ALBERT A. WEBB ASSOCIATES CIVIL ENGINEERS RIVERSIDE, CALIFORNIA APPROVED BY <i>[Signature]</i> DATE 2/4/65 R.E. No. 2876	CITY OF RIVERSIDE, CALIFORNIA DEPARTMENT OF PUBLIC WORKS APPROVED BY <i>[Signature]</i> DATE 9-2-65 DIRECTOR OF PUBLIC WORKS	SEWER PLAN AND PROFILE LINCOLN AVENUE TRACT NO 3147	PROJECT NO.
			S-609 SHEET 1 OF 2
W.O. 64-326 FOR: E.L. YEAGER DESIGNED BY <i>[Signature]</i> DRAWN BY <i>[Signature]</i> CHECKED BY B.O.S.	MARK: ADDED 1444, L.W.E. / ENCL. V.C.D. # 117 REVISIONS: 1 APPR. DATE: 9-2-65	HORIZ. SCALE: 1" = 50' VERT. SCALE: 1" = 5'	FILE NO. 64-326 P

ALBERT A. WEBB ASSOCIATES CIVIL ENGINEERS RIVERSIDE, CALIFORNIA APPROVED BY: <i>[Signature]</i> DATE: 7/4/65 R.E. No. 9876		CITY OF RIVERSIDE, CALIFORNIA DEPARTMENT OF PUBLIC WORKS APPROVED BY: <i>[Signature]</i> DATE: 9-2-65 DIRECTOR OF PUBLIC WORKS		PROJECT NO. S-609 SHEET 2 OF 2
W.O. 64-326 FOR: E.L. YEAGER	F.B. 960	DESIGNED BY: <i>[Signature]</i> DRAWN BY: <i>[Signature]</i> CHECKED BY: <i>[Signature]</i>	MARK: <i>[Signature]</i> REVISIONS: <i>[Signature]</i> APRIL DATE:	HORIZ. SCALE: 1" = 50' VERT. SCALE: 1" = 5' FILE NO. 64-326 P.

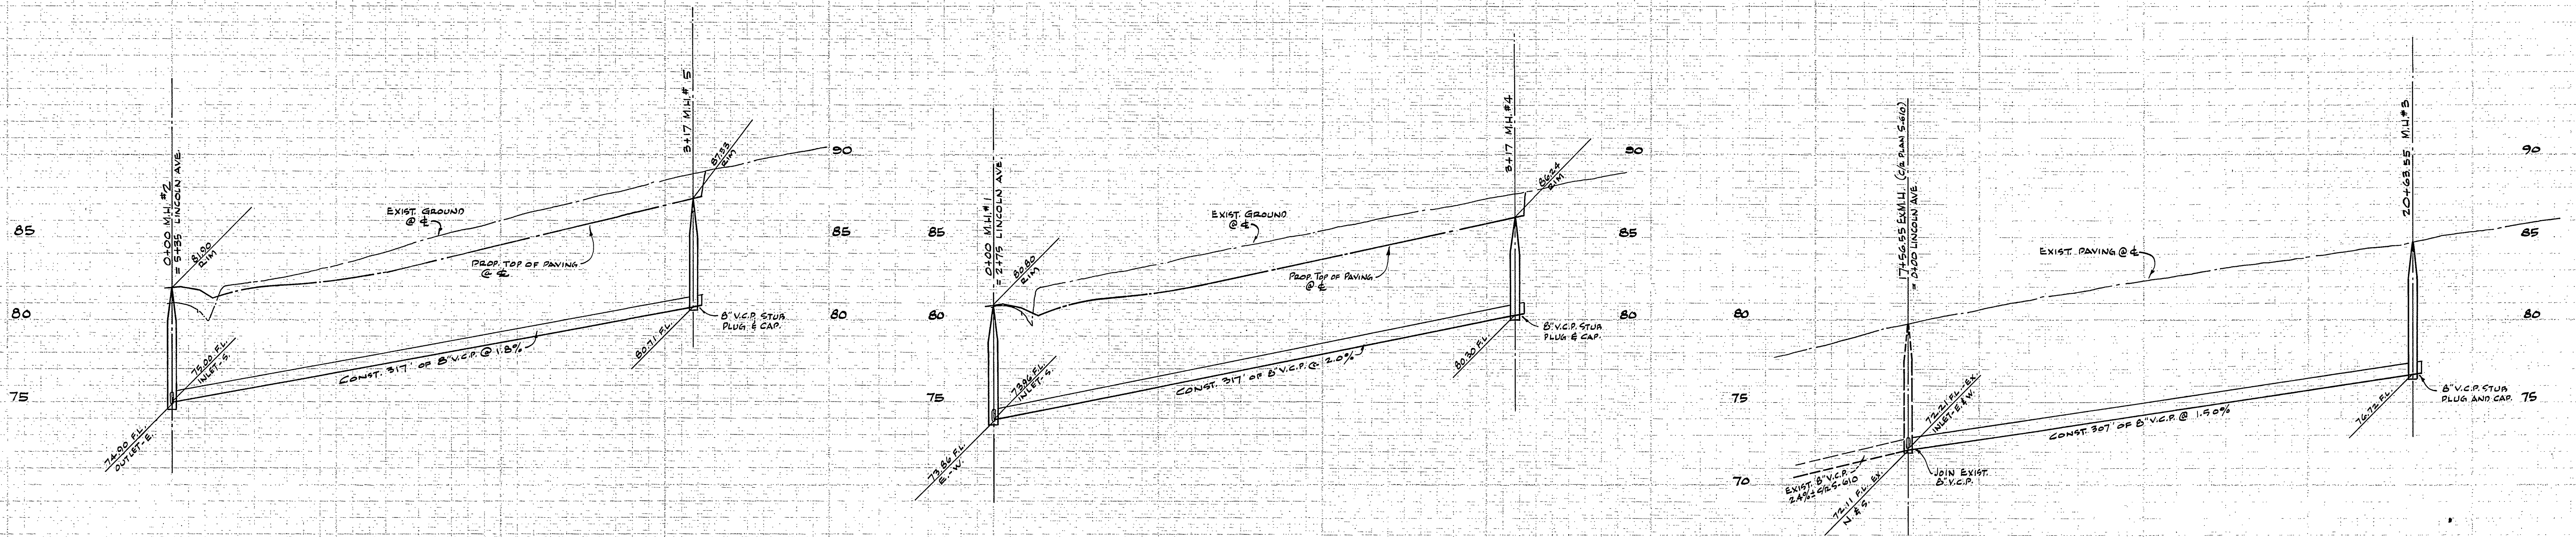
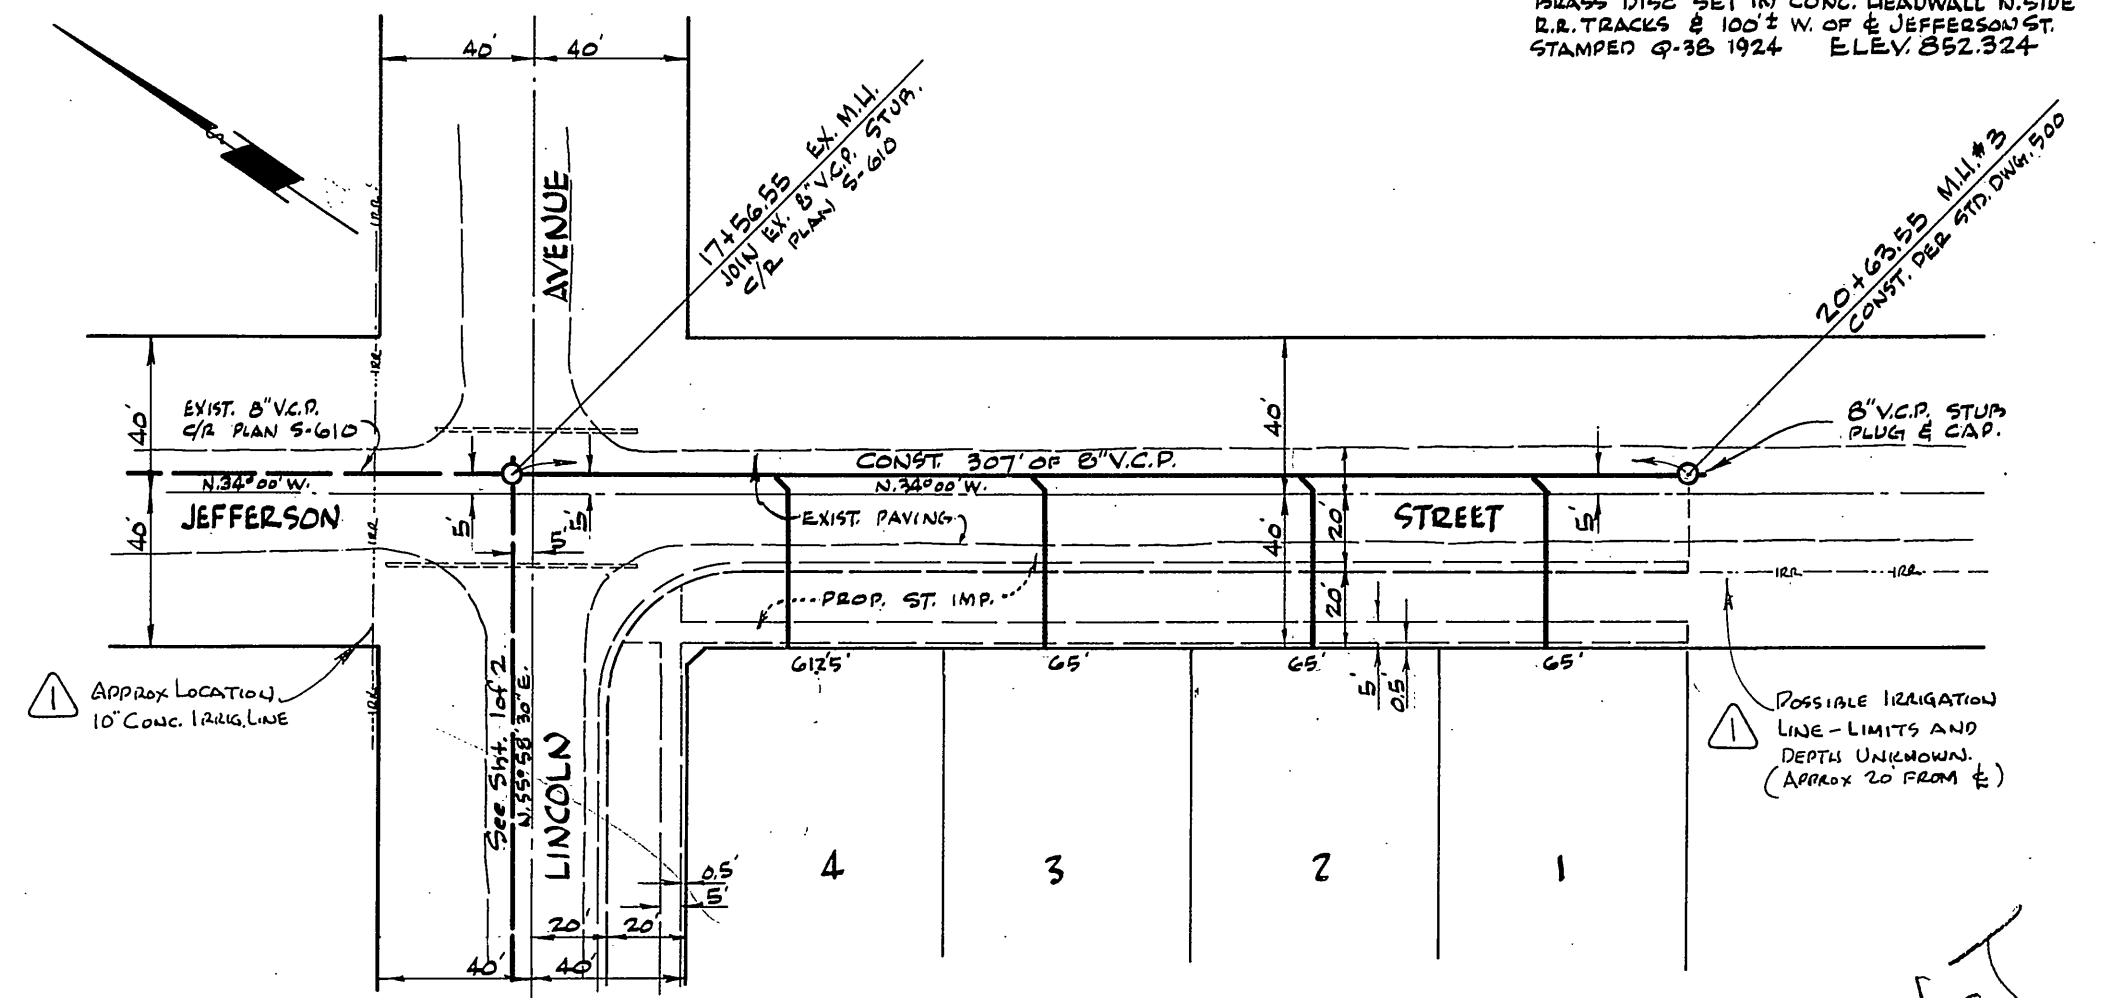
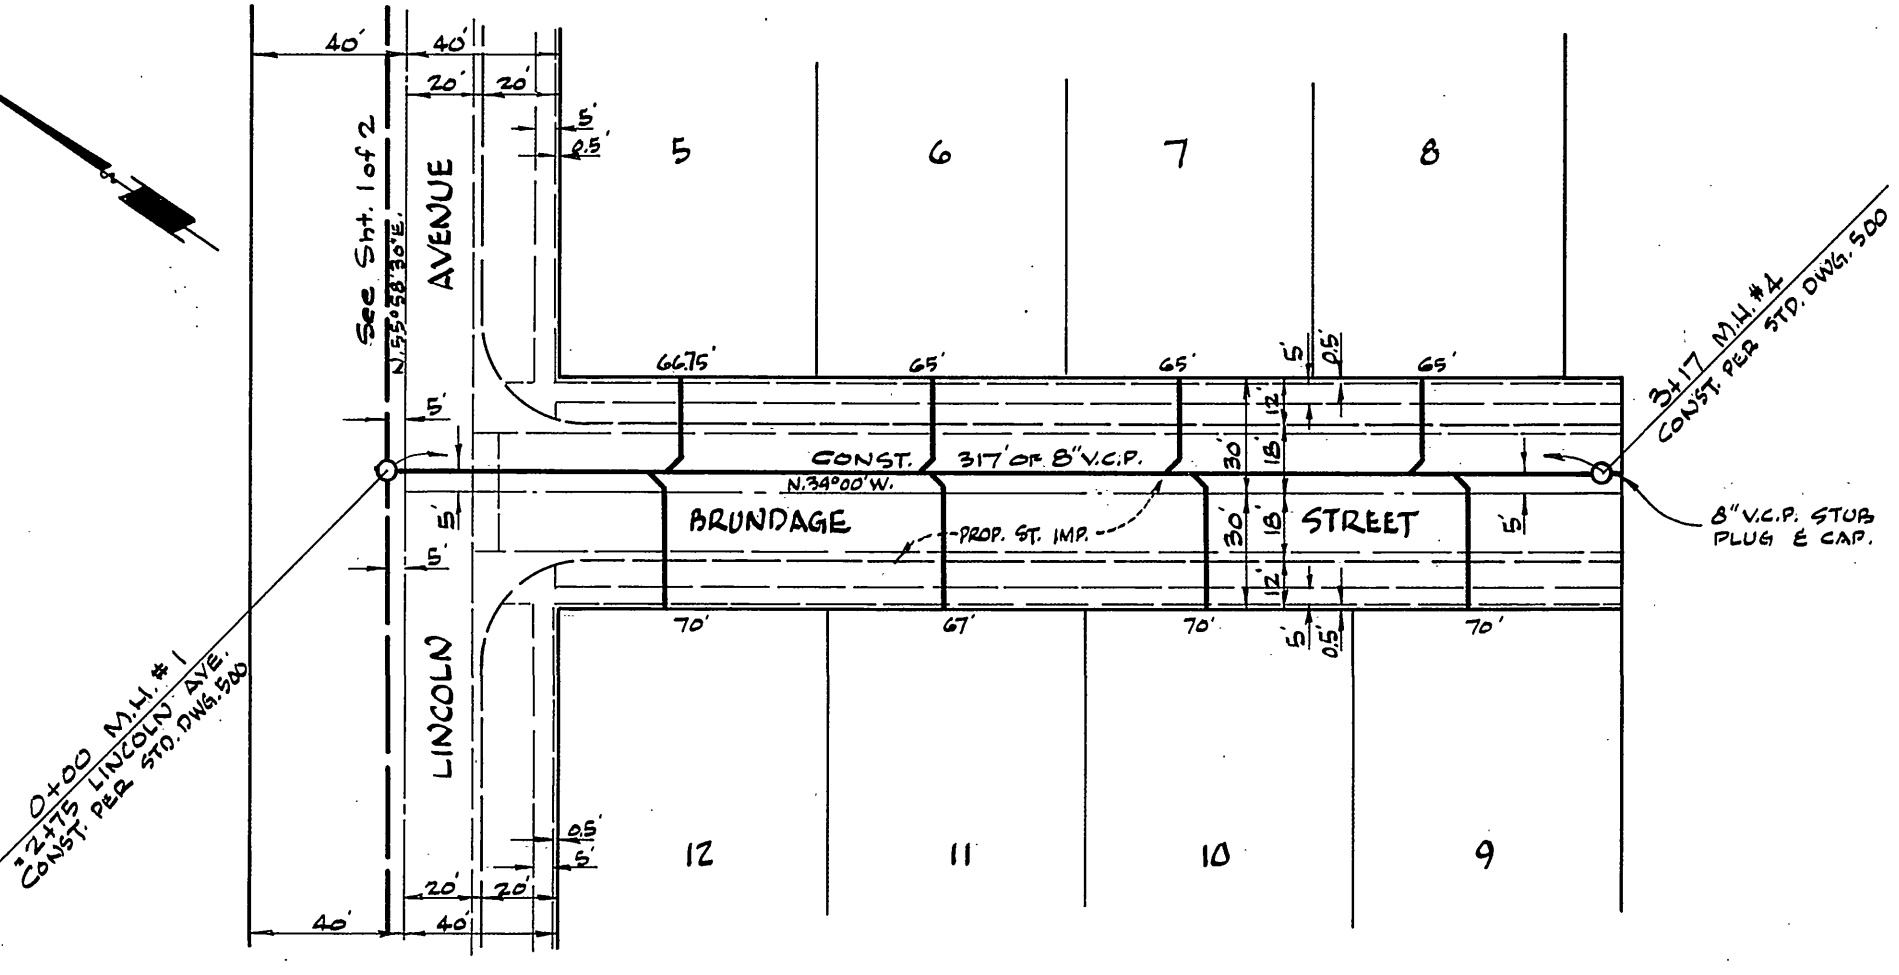
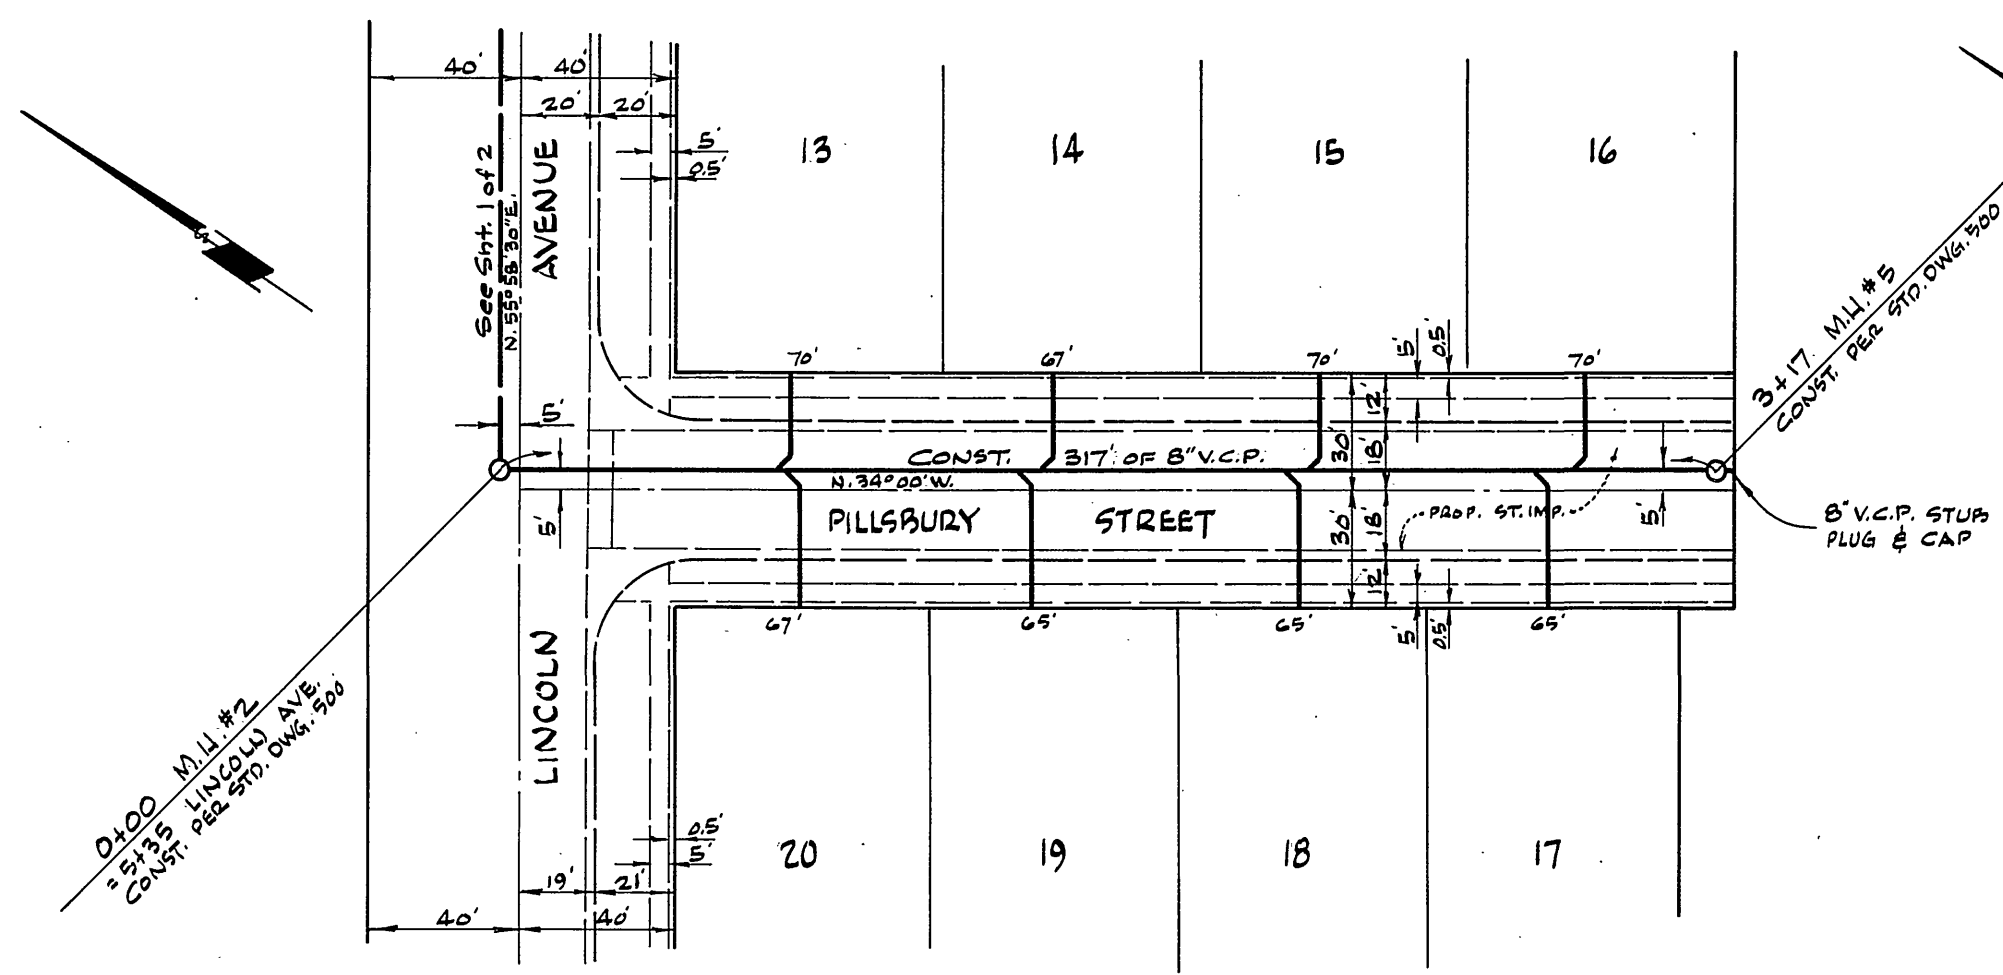
*VOID - NOT BUILT
 A
 Here is a
 Run out of time
 BOBS*

*Work NOT BUILT
See Sht 1 of 2*
